AMENDMENTS TO THE DRAWINGS

FIG. 1

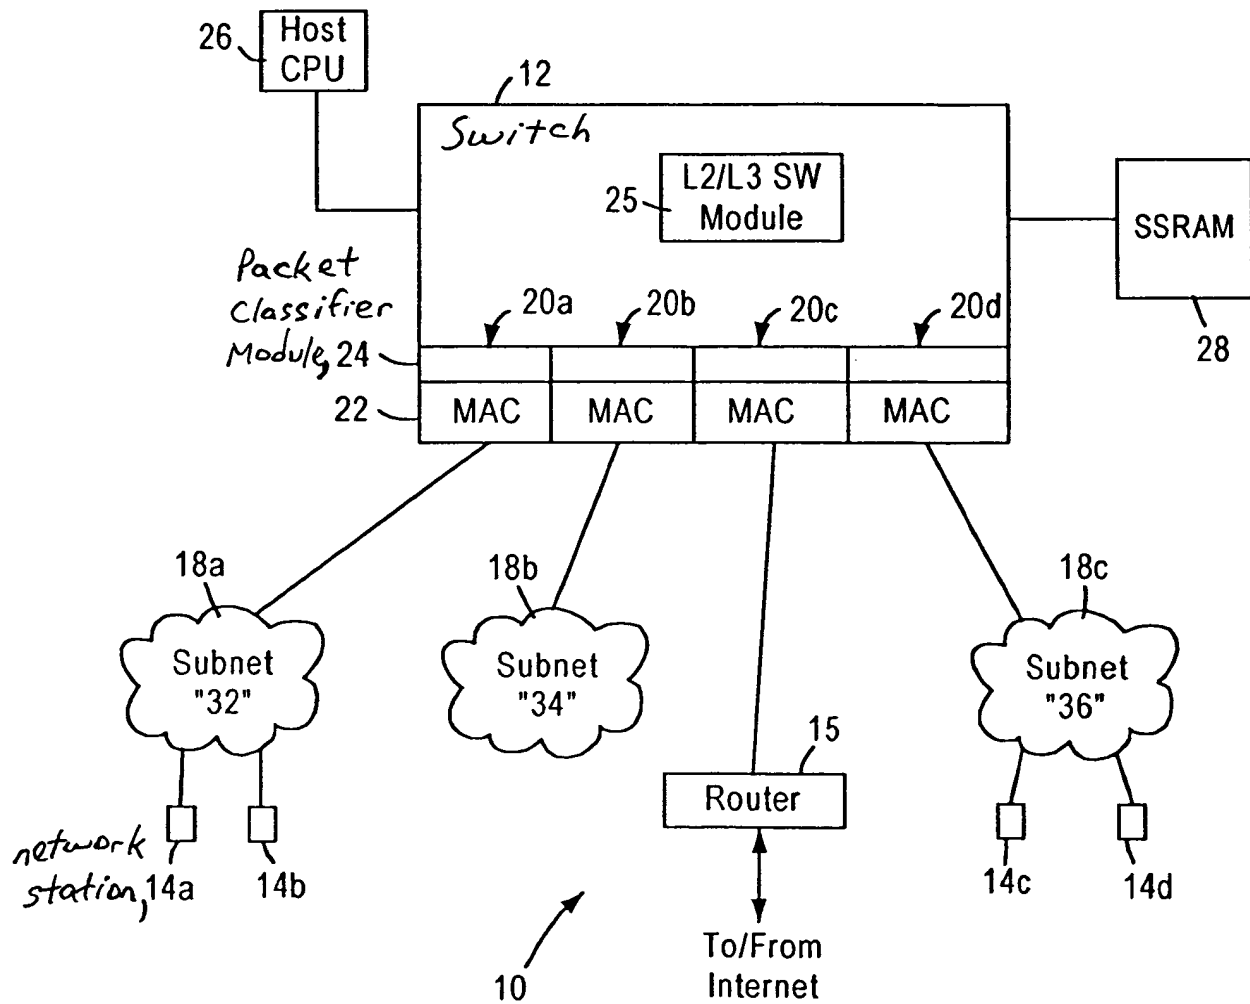
The attached two (2) sheets of drawings include changes to Fig. 1 and Fig. 2, respectively. The first sheet, which includes Fig. 1, includes descriptive wording for elements 12, 24, and 14. The second sheet, which includes Fig. 2, corrects the numerals below the columns labelled "IP" and "VLAN" to --32b-- and --12b--, respectively, and adds reference lines to identify the labeling for elements 40.
